Re: Docket No.: 70-3070
Louisiana Energy Services
Claiborne Enrichment Center
Revisions to Licensing Documents
File: 6046-00-2001.01

Attachment A
Specific Responses to NRC RAI

Louisiana Energy Services
Proposed License Conditions
Push-Pull Instructions
Revision 7, March 29, 1994

Figure 5.2-1

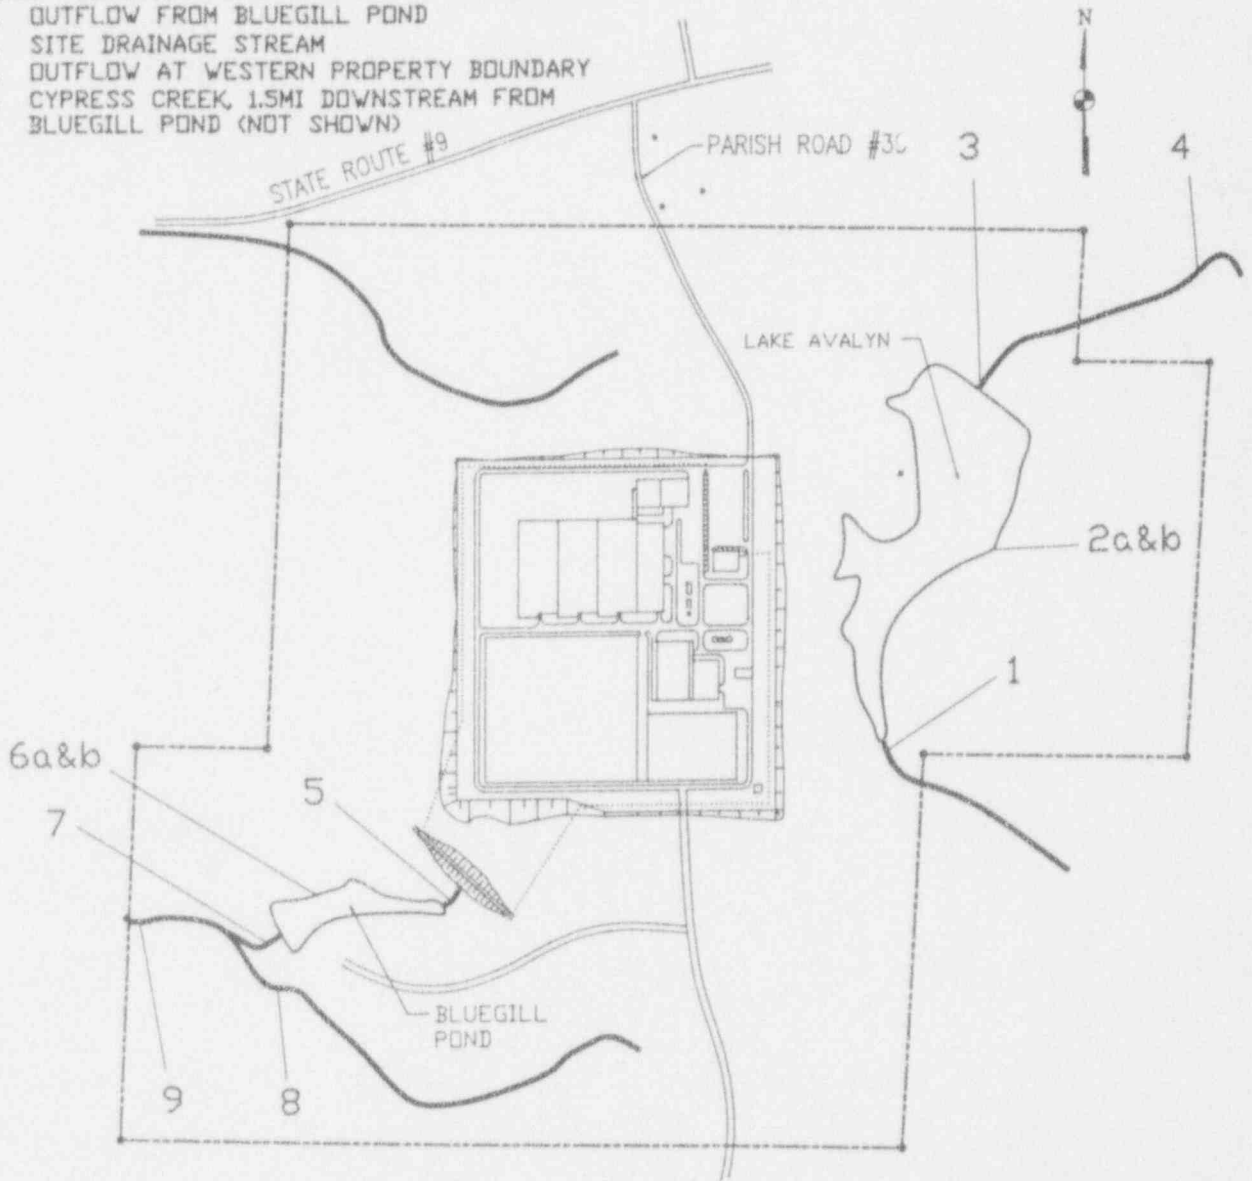
1. **Revise ER Figure 6.2-1 and Proposed License Conditions (PLC) Figure 5.2-1 to reflect correct sampling locations.**

ER Figure 6.2-1 and PLC Figure 5.2-1 have been revised to reflect correct sampling locations.
